Subject: **Response to City of San Diego LDR Geology**  
Proposed Fanelli-Huber Residence  
1851 Spindrift Drive  
La Jolla, California

City Project No. 693529, Cycle 1 dated August 20, 2021

In accordance with your request and authorization, **Geotechnical Exploration, Inc. (GEI)** is providing this addendum report to respond to the LDR-Geology review issues dated August 20, 2021 as part of the City of San Diego Review process. This report is written in a format first stating the City Reviewer Comment/Question from the August 20, 2021, review followed by our response. Refer to the Vicinity Map, Figure No. I, for the project location. It is our understanding that the following documents referenced in the memorandum have been reviewed:

Fanelti-Huber Residence  
1857 Spindrift Drive  
La Jolla, CA.  
Figure No. II  
Job No. 21-13237

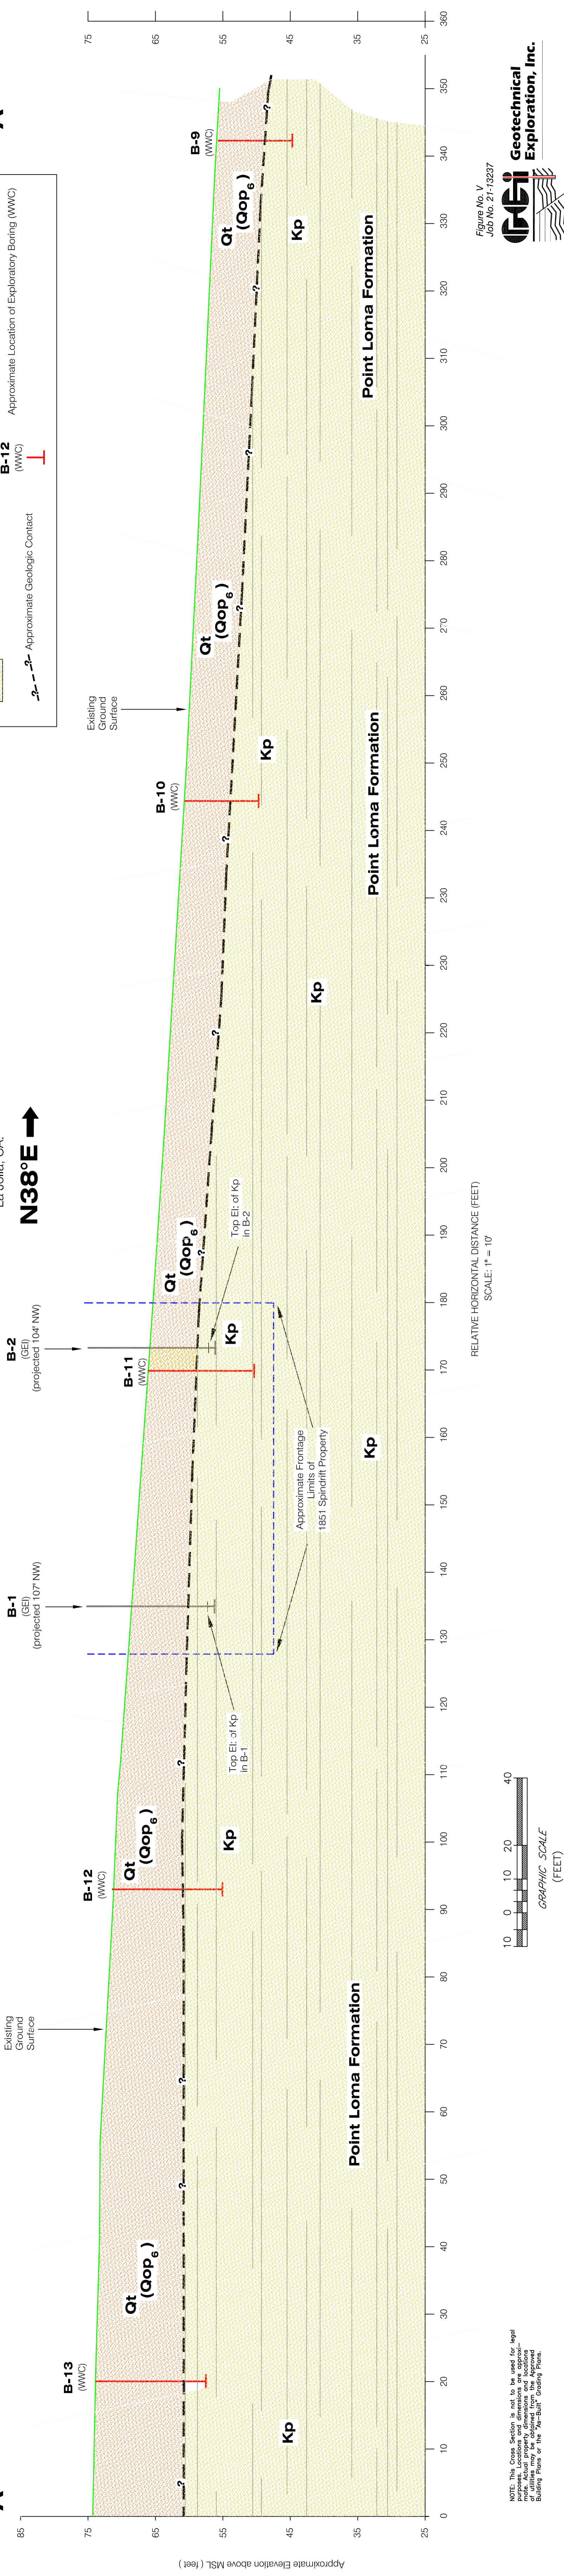
*City Cycle 1, Issue No. 6: (New Issue) If the project's geotechnical consultant is relying on subsurface information from adjacent sites for their site specific fault hazard investigation, the consultant should show all offsite exploratory excavations utilized to support their conclusions regarding the absence of hazardous faults on or adjacent to the subject site on their Plot Plan and Site Specific Geologic Map, Figure No. II.*

**GEI Response:** The attached Figure No. II, Site Plan and Site-Specific Geologic Map, depicts the off-site borings by Artim and Streiff (1981) and the recently drilled on-site borings by GEI. In addition, GEI performed geologic mapping of the coastal bluff off-site to the northeast (refer to Reference 2 above, GEI, 2021, Figure No. VIb, reproduced for this response letter as Figure No. VIII). Results of the borings and bluff mapping are discussed above in the response for Issue Nos. 4 and 5.

Figure No. V  
Job No. 21-13237

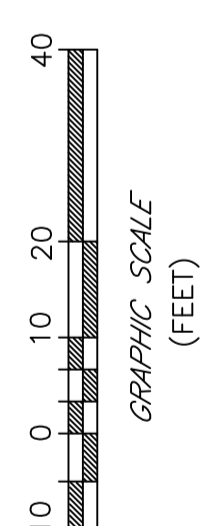
*City Cycle 1, Issue No. 8: (New Issue) The project's geotechnical consultant should provide detailed geologic cross sections that demonstrate stratigraphic/structural continuity across the subject site. The cross sections should demonstrate continuity between the subject site geotechnical investigation and the offsite fault trenches or excavations used for the site-specific fault evaluation.*

The results of the drilling indicated that the surface elevation of the underlying Point Loma Formation beneath the site is at a depth of 18 feet and, as anticipated, is very similar to the elevations noted in the Artim and Streiff borings northwest of and adjacent to the site. Cross section A-A' (Figure No. V), specifically in the area of Station Nos. 130 through 180 feet, depicts the Artim and Streiff borings and the GEI borings. GEI Borings B-1 and B-2 are projected 107 feet northwest to the Spindrifft Drive cross section. The cross section reveals that the elevations of the underlying Point Loma Formation surface are essentially the same on Spindrifft Drive in front of the property and in the rear yard of the home. Figure No. VI presents cross section B-B' across the rear yard, and Figure No. VII presents cross section C-C', drawn perpendicular to A-A' and B-B'.

**GEI Response:** As indicated above in our response to Issue No. 4, cross section A-A' along the portion of Spindrift Drive northwest of the subject site and cross section B-B' across the rear yard parallel to A-A', are attached as Figure Nos. V and VI. In addition, cross section C-C' crossing the site perpendicular to A-A' and B-B' is presented as Figure No. VII. Cross section A-A' depicts the interpreted continuity of the underlying surface of the Cretaceous Point Loma Formation. When compared with elevations of the Point Loma Formation in cross section B-B', it is our opinion that there is no significant bedrock faulting that offsets the overlying marine terrace deposits beneath the subject lot. Cross section C-C' shows the continuity in elevation between cross sections A-A' and B-B'.

Figure No. VIII

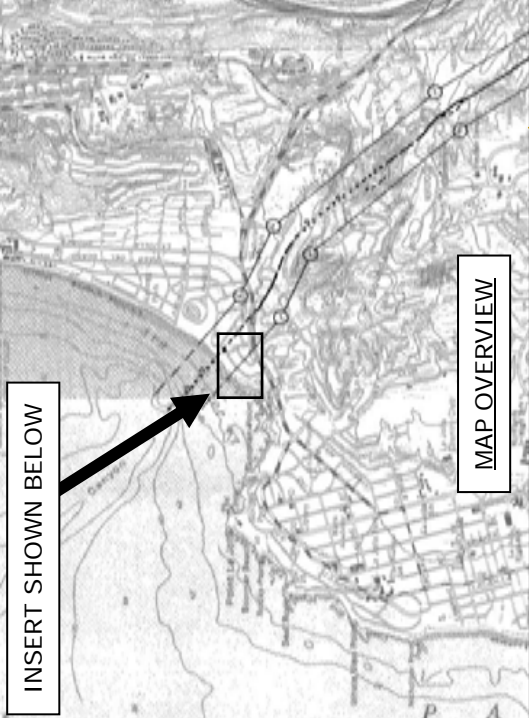
*City Cycle 1, Issue No. 5: (New Issue) If the project's geotechnical consultant is relying on subsurface information from adjacent sites for their site specific fault hazard investigation, the consultant must reference the offsite geotechnical reports utilized to support their conclusions regarding the absence of hazardous faults and state that they agree with the fault investigation data and conclusions contained in those report.*

In addition, GEI is utilizing geologic mapping of the coastal bluff off-site to the northwest (refer to Reference 2 above, GEI, 2021, Figure No. VIb, reproduced herein as Figure No. VIII), which is parallel to Spindrifft Drive in the section next to the subject property. With three sets of data points regarding the surface of the underlying Point Loma Formation located at the mapped bluff, the borings in Spindrifft Drive and the on-site borings, we interpret and conclude that the Point Loma Formation is not offset or faulted from a significant strike-slip fault standpoint at the subject lot.
